Discussion of Modifications to 802.1AS-2020 to Resolve Maintenance Items 369, 371, and 372

Revision 2

IEEE 802.1 Maintenance TG
2024.09.10

Figure 12-7. TimeReceiver state machine

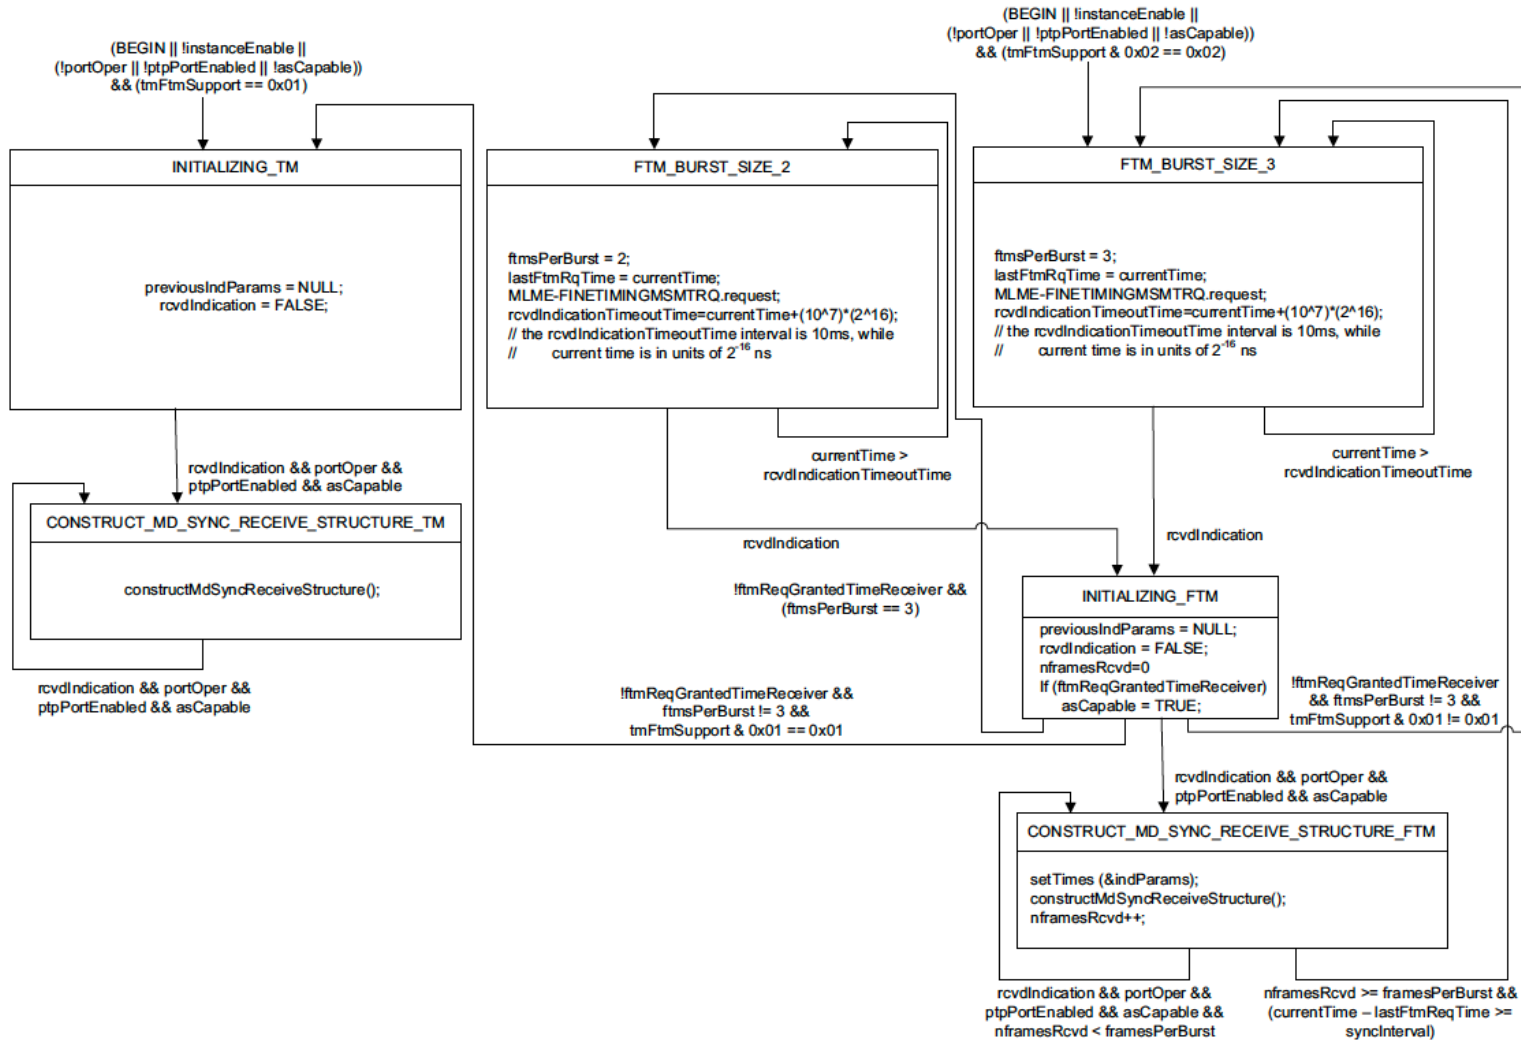
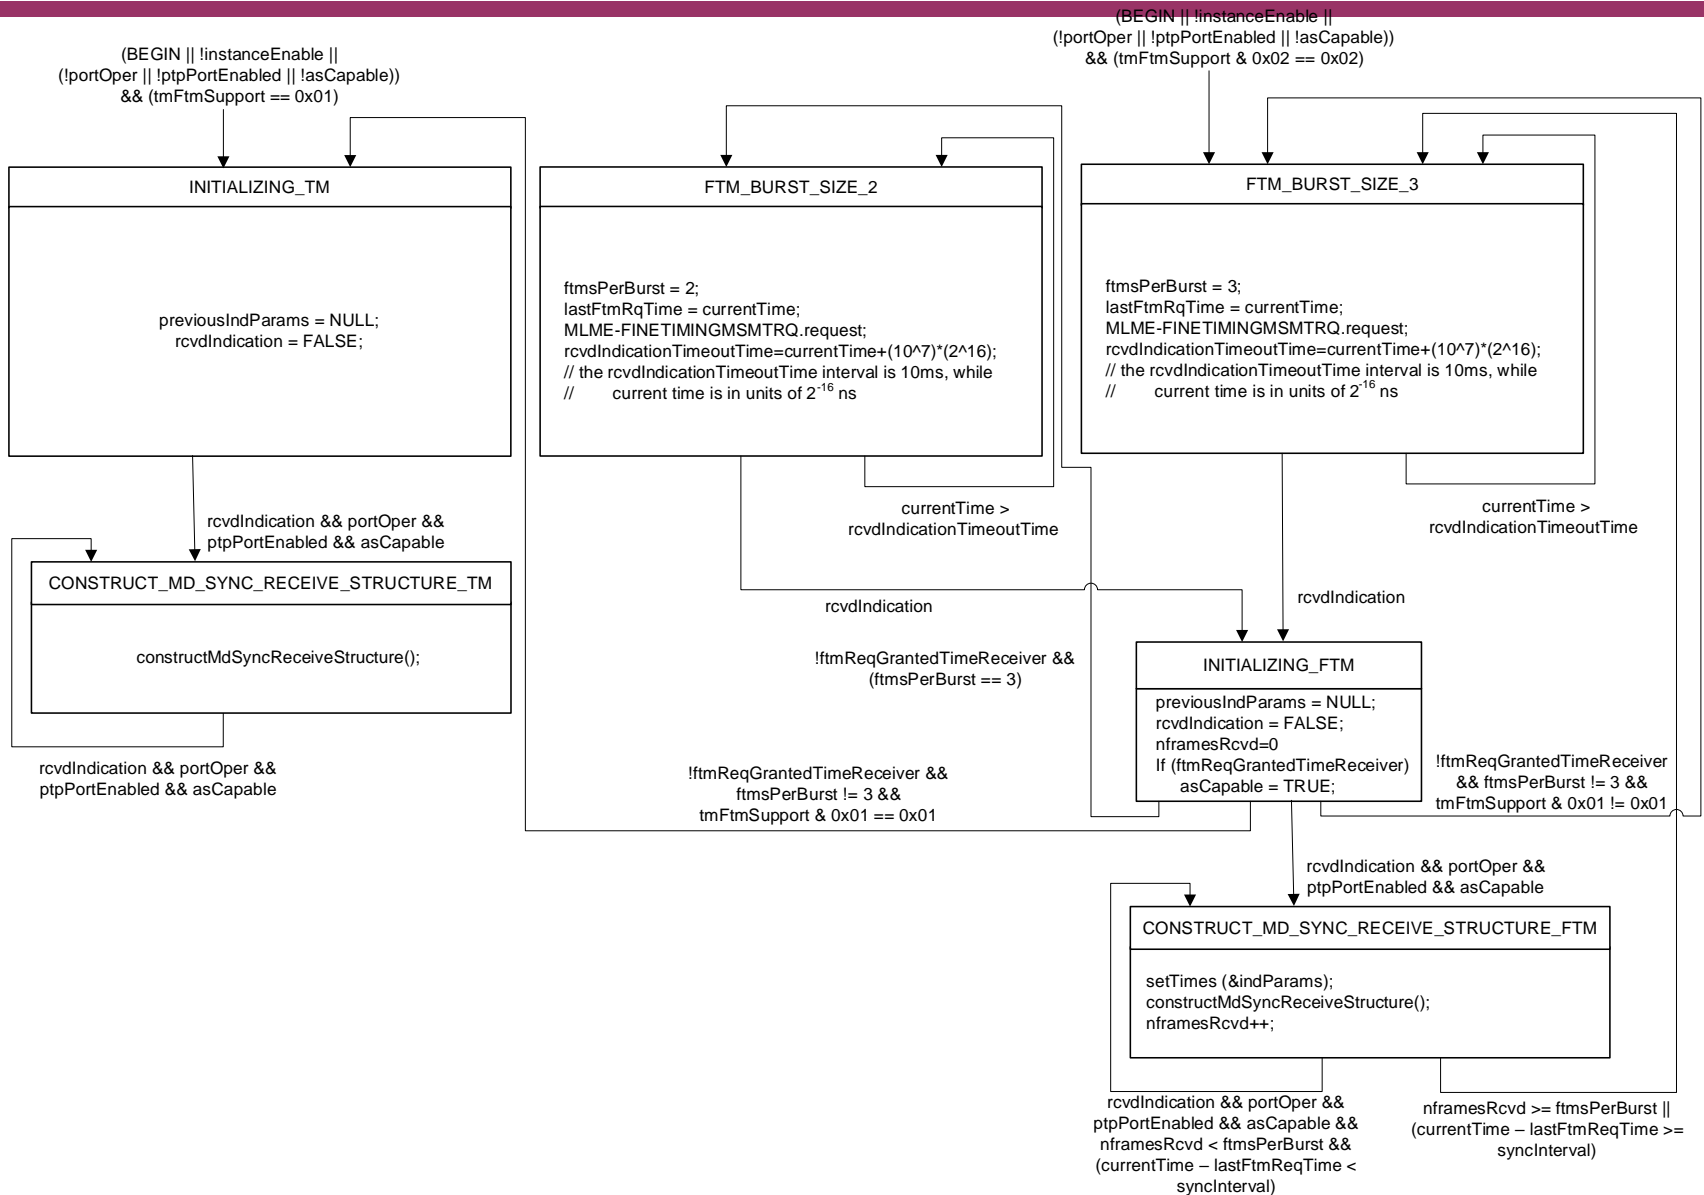
There is a mix of names in the slave state machine (Fig. 12-7) . It seems that "ftmsPerBurst" and "framesPerBursts" is used for the same variable.

- ❑ The second and third statements are not needed, as their functionality is contained in the `CONSTRUCT_MD_SYNC_RECEIVE_STRUCTURE_FTM` state

- Note that the variable `RESTART` is not set and is not used anywhere else
- Inspection of earlier drafts of 802.1AS-2020 indicates that this had been used in the earlier drafts; however, the variable was subsequently eliminated and the `TimeReceiver` state machine was revised
- The second and third statements of the first else if block of `constructMdSyncReceiveStructure()`; should have been deleted when the state machine was revised

□ In addition, the condition

▪ $nframesRcvd \geq framesPerBurst \ \&\& \ (currentTime - lastFtmReqTime \geq syncInterval)$

□ in the right-hand transition out of the `CONSTRUCT_MD_SYNC_RECEIVE_STRUCTURE_FTM` state should be

▪ $nframesRcvd \geq framesPerBurst \ || \ (currentTime - lastFtmReqTime \geq syncInterval)$

□ because this transition should occur if either condition occurs.

Likewise, the transition out of the left-hand branch from this state should occur only if a timeout has not occurred, i.e., the transition should be

▪ $rcvdIndication \ \&\& \ portOper \ \&\& \ ptpPortEnabled \ \&\& \ asCapable \ \&\& \ (nframesRcvd < framesPerBurst) \ \&\& \ (currentTime - lastFtmReqTime < syncInterval)$

- ❑ As indicated in the maintenance item rationale for revision, both `framesPerBurst` and `ftmsPerBurst` are used in Figure 12-7
- ❑ `ftmsPerBurst` is defined in 12.5.2.3.8 as a local variable for the media-dependent `TimeReceiver` state machine:

- ❑ In the normal case, where the request is granted, this is the same as `ftmsPerBurst` of 12.5.2.3.8 of 802.1AS-2020, and was intended by the stand-alone local variable “`framesPerBurst`” in Figure 12-7
- ❑ Based on this discussion, the stand-alone local variable “`framesPerBurst`” in Figure 12-7 should be changed to “`ftmsPerBurst`”
- ❑ In addition, for consistency the nomenclature used in 802.11-2020, the instances where “`framesPerBurst`” is used as the name of members of the `initReqParamsDot11TimeTransmitter` and `initReqParamsDot11TimeReceiver` structures can be changed to “`ftmsPerBurst`”

□ In Figure 12-7, change the condition on the branch from the CONSTRUCT_MD_SYNC_RECEIVE_STRUCTURE_FTM state to the FTM_BURST_SIZE_3 state to:

- nframesRcvd >= framesPerBurst || (currentTime – lastFtmReqTime >= syncInterval)

- ❑ In Figure 12-7, change the condition on the branch from the `CONSTRUCT_MD_SYNC_RECEIVE_STRUCTURE_FTM` state back to itself (i.e., the left branch):
 - `rcvdIndication && portOper && ptpPortEnabled && asCapable && (nframesRcvd < framesPerBurst) && (currentTime – lastFtmReqTime < syncInterval)`
- ❑ The revised Figure 12-7, with changes due to all the items discussed in this presentation, is given at the end of the presentation

- Change “framesPerBurst” to “ftmsPerBurst” in the conditions exiting the CONSTRUCT_MD_SYNC_STRUCTURE_FTM state of Figure 12-7
- Change “framesPerBurst” to “ftmsPerBurst” in the following places:
 - Figure 12-6 (2 places, where it is a member of the structure initReqParamsDot11TimeTransmitterB)
 - 12.5.1.4.5, fourth line of the function initRequestWaitConfirm(), where it is a member of the structure initReqParamsDot11TimeTransmitterB
 - 12.5.2.4.4, ninth line of the function constructMdSyncReceiveStructure(), where it is a member of the structure initReqParamsDot11TimeReceiver

Figure 12-2—Fine Timing Measurement procedure for IEEE 802.11 links

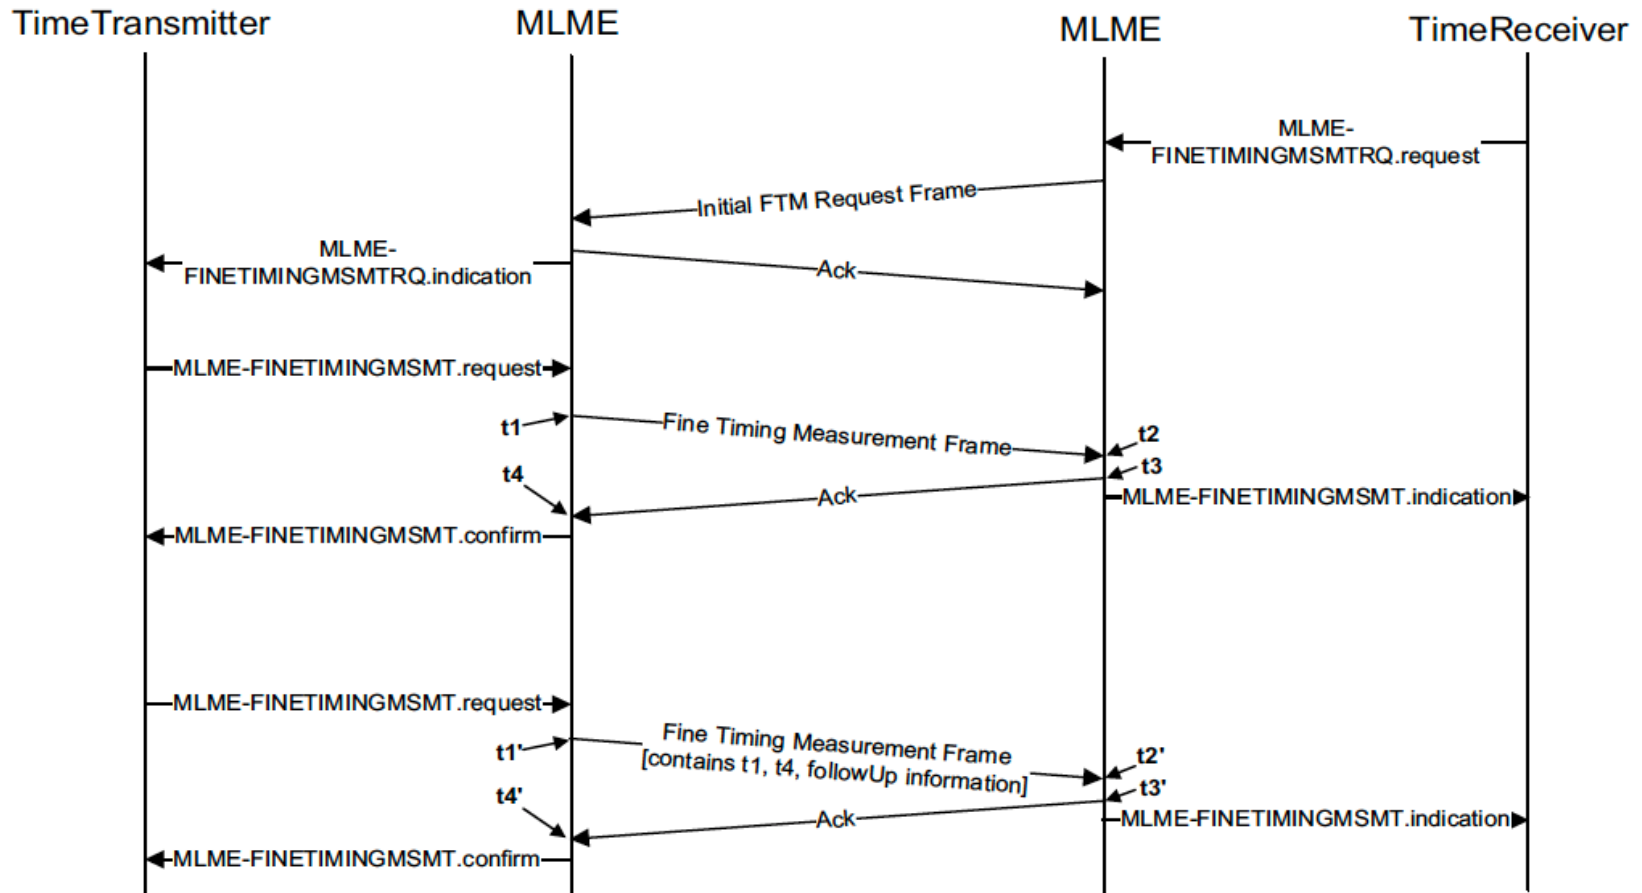
- ❑ Figure 12-2, copied on the next slide, shows the FTM procedure
- ❑ It is clear from this figure that `TimeReceiver` issues the `MLME-FINETIMINGMSMTRQ.request` primitive, and not the `MLME-FINETIMINGMSMTRQ.indication` primitive
 - The `MLME-FINETIMINGMSMTRQ.indication` primitive is issued by the MLME to the `TimeTransmitter`
- ❑ Therefore, this maintenance item can be resolved by accepting the proposed text, i.e.,

Change paragraph to: "A structure whose members contain the values of the fields of an `MLME-FINETIMINGMSMTRQ.request` primitive."

Revised Figure 12-5

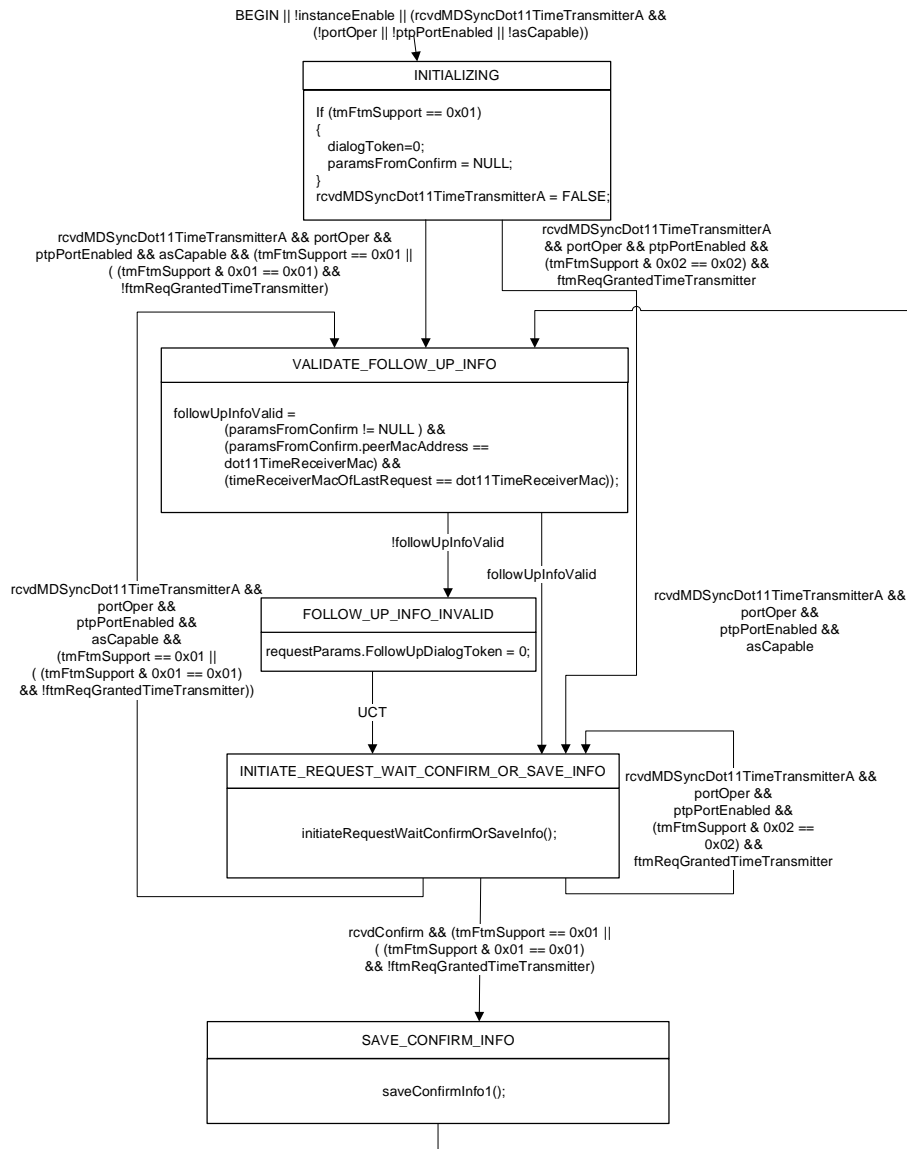
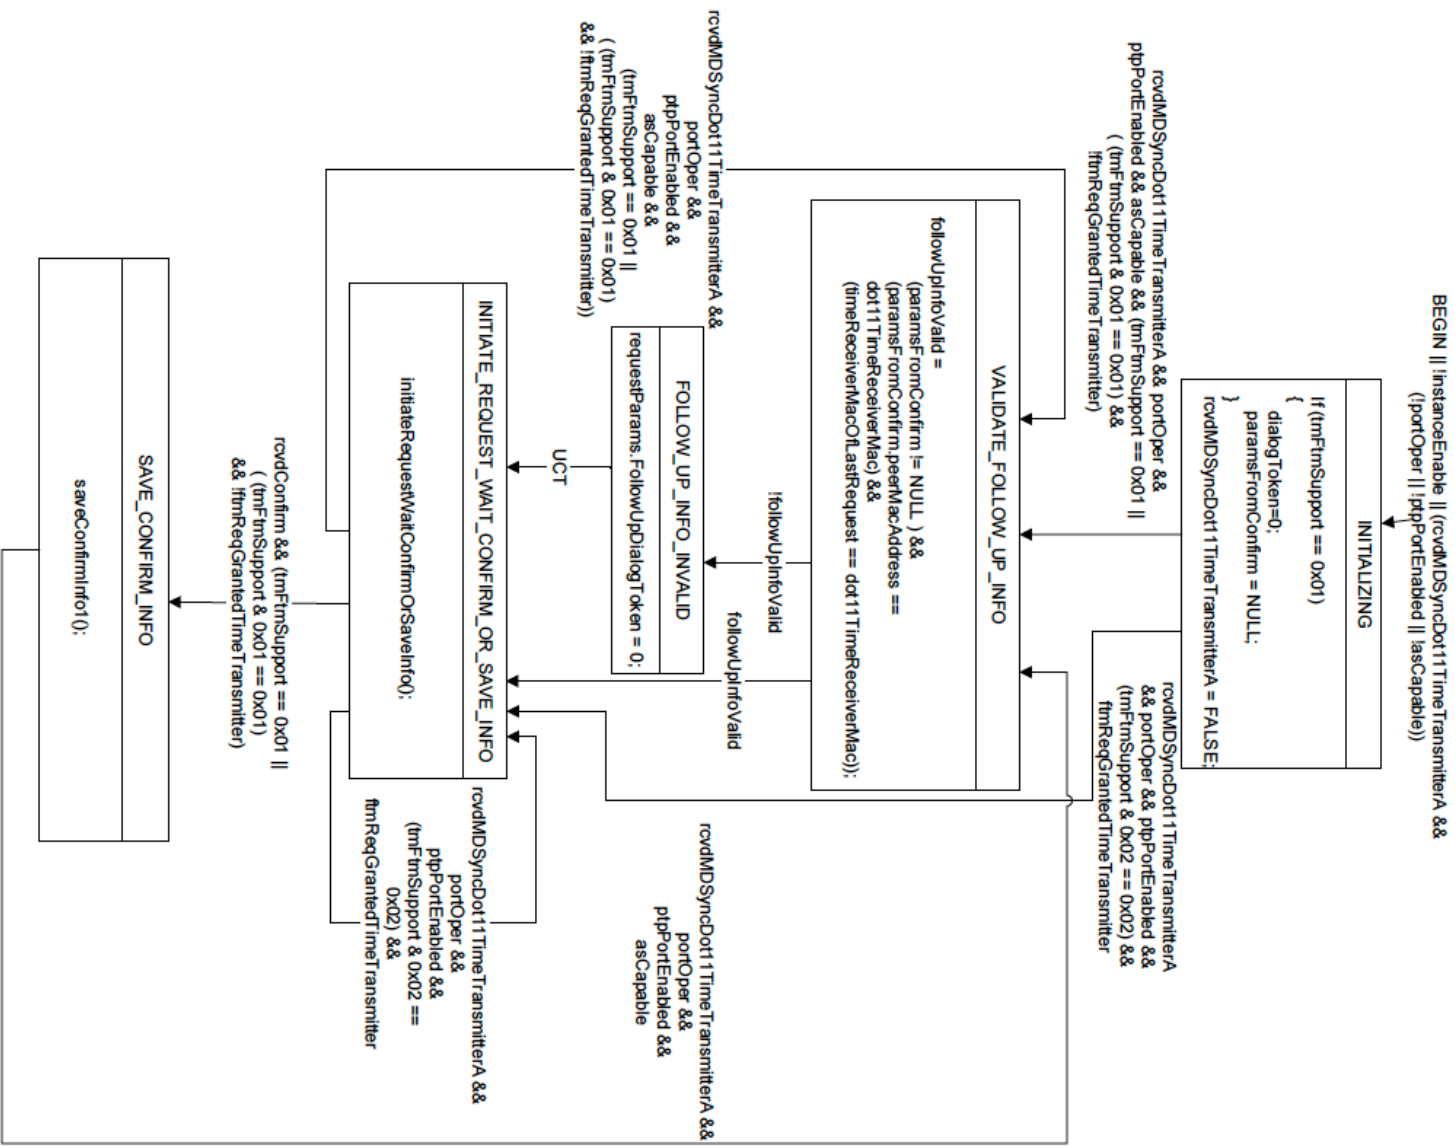
- ❑ In Figure 12-5, in the state transition between the INITIALIZING and VALIDATE_FOLLOW_UP_INFO states, “ftmRequGrantedTimeTransmitter” should be changed to “ftmReqGrantedTimeTransmitter” (i.e., change “Requ” to “Req”) in the condition for this transition

- ❑ In addition, the conditions for the transitions from the INITIALIZING to VALIDATE_FOLLOW_UP_INFO state, from the INITIATE_REQUEST_WAIT_CONFIRM_OR_SAVE INFO to VALIDATE_FOLLOW_UP_INFO state, and from the INITIATE_REQUEST_WAIT_CONFIRM_OR_SAVE INFO to SAVE_CONFIRM_INFO state contain the condition (note the change indicated in the first bullet item above):

- $(tmFtmSupport == 0x01 \parallel (tmFtmSupport \& 0x01 == 0x01) \&\& ftmReqGrantedTimeTransmitter)$
- ❑ However, ftmReqGrantedTimeTransmitter is part of the checking for the case where TM is supported; this check is being done because the FTM request was not granted and TM is to be used instead if it is supported

- ❑ Also, the transitions (a) from the INITIALIZING to the INITIATE_REQUEST_WAIT_CONFIRM_OR_SAVE_INFO state, and (b) from the INITIATE_REQUEST_WAIT_CONFIRM_OR_SAVE_INFO state to itself also require that the FTM request was granted, i.e., that ftmReqGrantedTimeTransmitter is TRUE

- ❑ Based on the above, “ftmReqGrantedTimeTransmitter” should be changed to “!ftmReqGrantedTimeTransmitter” in the above three state transition conditions in Figure 12-5

- The former transition condition becomes:
 - `rcvdMDSyncDot11TimeTransmitterA && portOper && ptpPortEnabled && (tmFtmSupport & 0x02 == 0x02) && ftmReqGrantedTimeTransmitter`

- The latter transition becomes:
 - `rcvdMDSyncDot11TimeTransmitterA && portOper && ptpPortEnabled && (tmFtmSupport & 0x02 == 0x02) && ftmReqGrantedTimeTransmitter`
